Project: **ST GEORGE HOSPITAL  
EMERGENCY DEPARTMENT**

Report: **BCA ASSESSMENT REPORT**

Date: 20<sup>th</sup> March 2012

SK 1  
UTS  
4: 103206-ED-BCA-r2

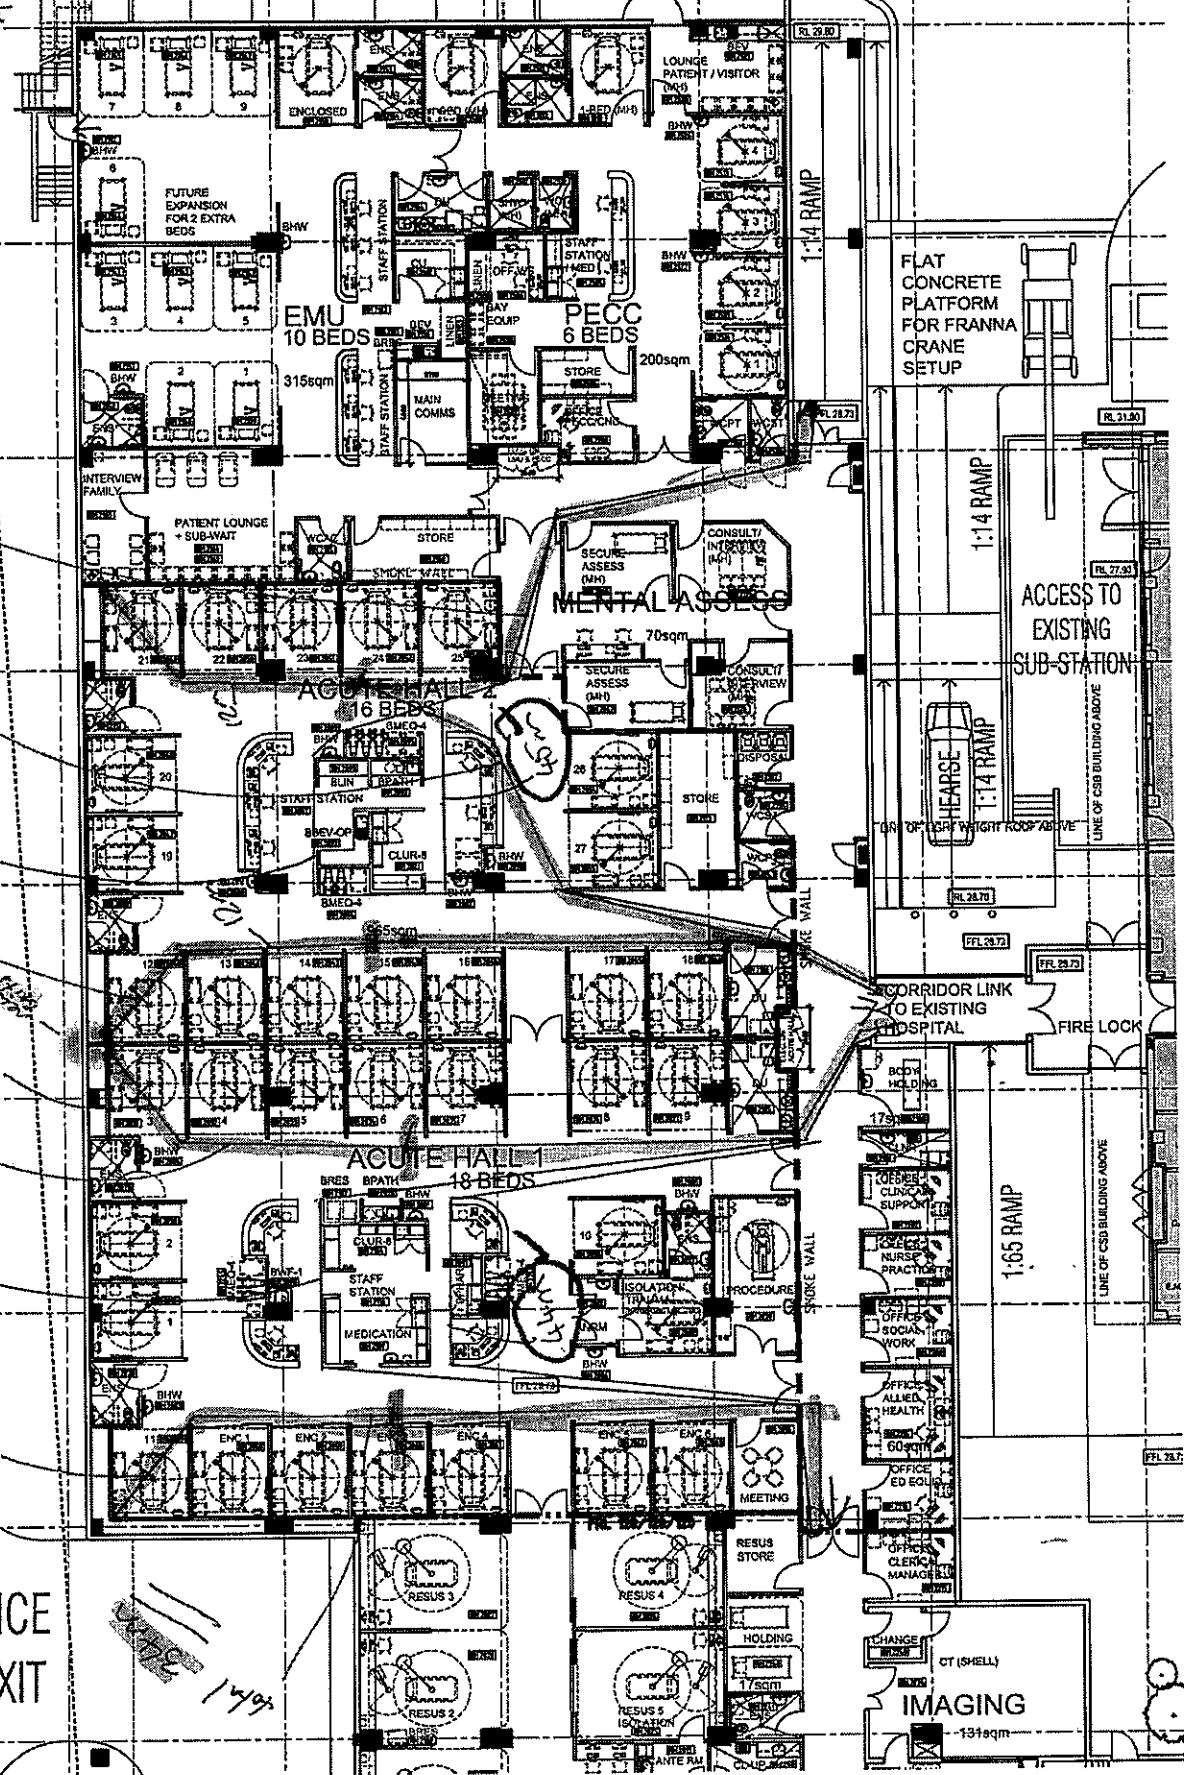
Given the exits as noted in Part 2 of this report a number of areas are not provided with compliant travel distances within the ground floor area. These areas are marked on an attached drawing.

Within the Class 9a areas the travel distance is required to be no more than 12m to a point of choice with a total exit travel distance of 30m.

As can be seen from the marked up drawings (SK1) the southern areas of the Acute Halls 1 and 2 are more than 12m to a point of choice where alternate exits are a compliant distance apart and the total travel distances exceed the permitted total 30m. It is recommended that an additional exit be provided around grid point A8 between the two Acute Halls with an external stairway as is proposed elsewhere in the building.
